BRIDGE

FOUNDATION INVESTIGATION REPORT
For

Proposed New Structure at Relocated
Hwy. #35 (Line 'F') and Kushog Lake,
Co. of Haliburton, Twp. of Stanhope,
Con. X, Lot 1, Dist. #11 (Huntsville).

W.P. 177-64,
Ox Narrows Bridge,
Hwy. #35, Dist. #11 (Huntsville).

Stop Blocks to be cast after Girders are in place.

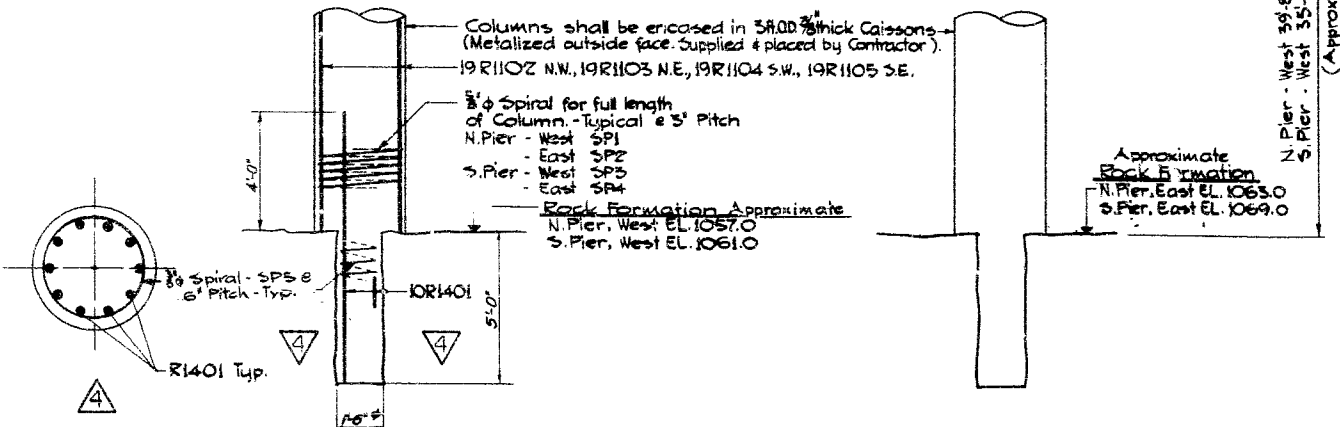
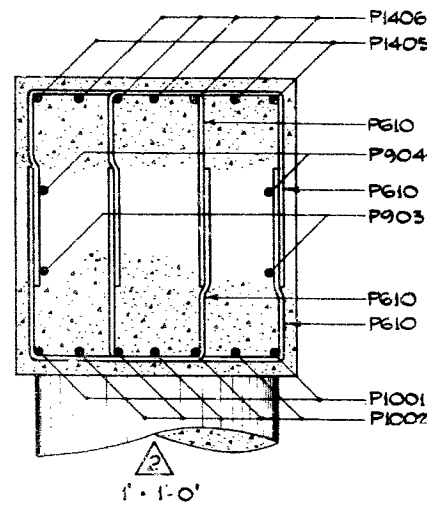
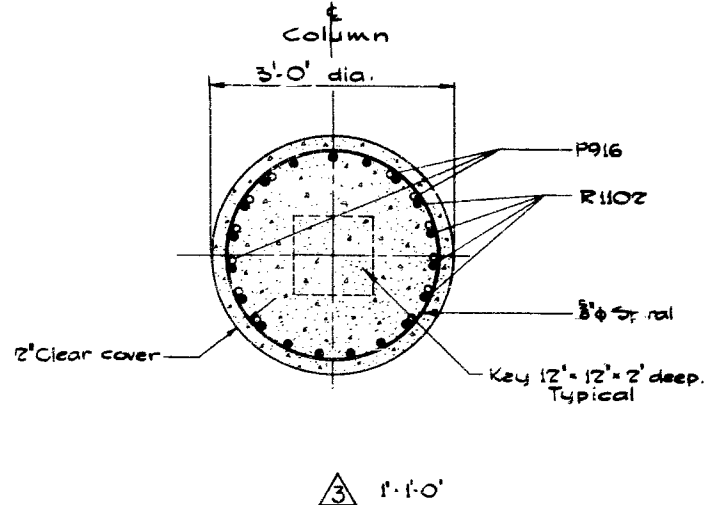
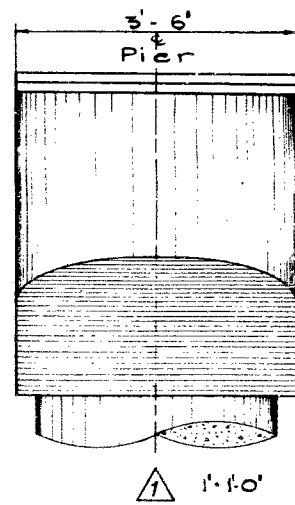
From the drawing D-5823-5, it is not clear what kind of connection is contemplated between the 3.0-ft. dia. caisson and the 1.5-ft. dia. key. We would suggest that the use of a 9-ft. long H-pile section be given consideration.
